Peninsula Hospital Site Redevelopment City Council Modification Technical Memorandum CEQR No. 18DCP124Q

III. MODIFICATIONS UNDER CONSIDERATION BY THE CITY COUNCIL

PROPOSED MODIFIED SITE PLAN

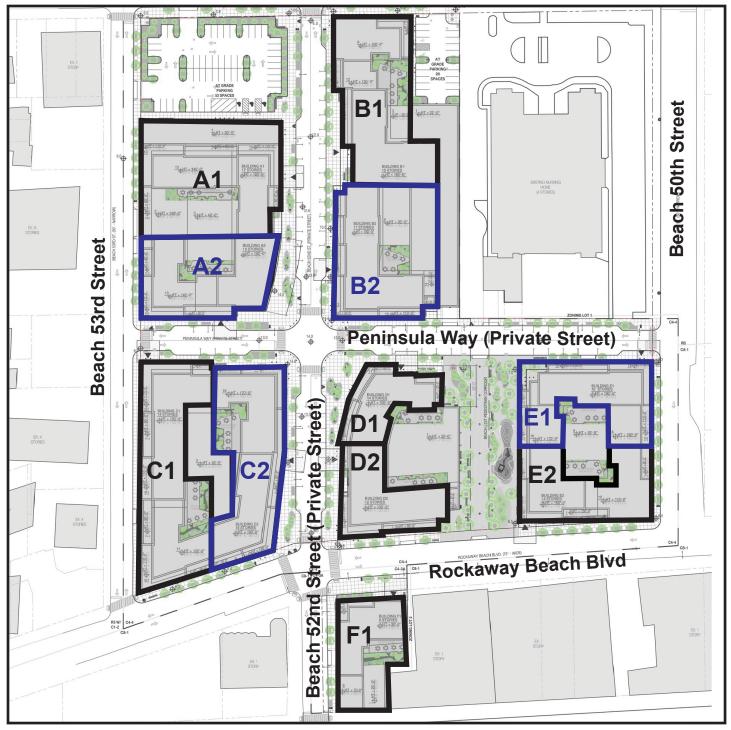
- in connection with the LSGD special permits, reduce the building heights of buildings A2, B2, C2 and E1 (see **Figure 1: Proposed Modified Site Plan**). Specifically, the heights of each of these buildings would be reduced by 10 feet compared to the heights of the buildings evaluated in the FEIS. The plans associated with the special permits are proposed to be updated accordingly.
- in the restrictive declaration attached to the LSGD special permit, require phasing of the Proposed Project as set forth in the mitigation measures, add the local councilmember as a party to be notified of the school mitigation implementation, and update the attached plans.
- in connection with the zoning text amendment, require MIH Option 1.

As a consequence of the height reduction modification noted above, the Applicant has elected to reduce the proposed residential floor area, resulting in a reduction in the number of dwelling units from 2,200 (as was analyzed in the FEIS) to approximately 2,050 DUs (see **Table 1: Proposed Modified Development**) – an estimated reduction of 150 DUs (these revisions by the applicant and the City Council Modifications are collectively referred to herein as the "Proposed Modified Development"). The Proposed Modified Development would retain designation of the Proposed Project under MIH Option 1: 25% of the residential floor area shall be provided as housing affordable to households at an average of 60% of AMI, with no unit targeted at a level exceeding 130% of AMI.
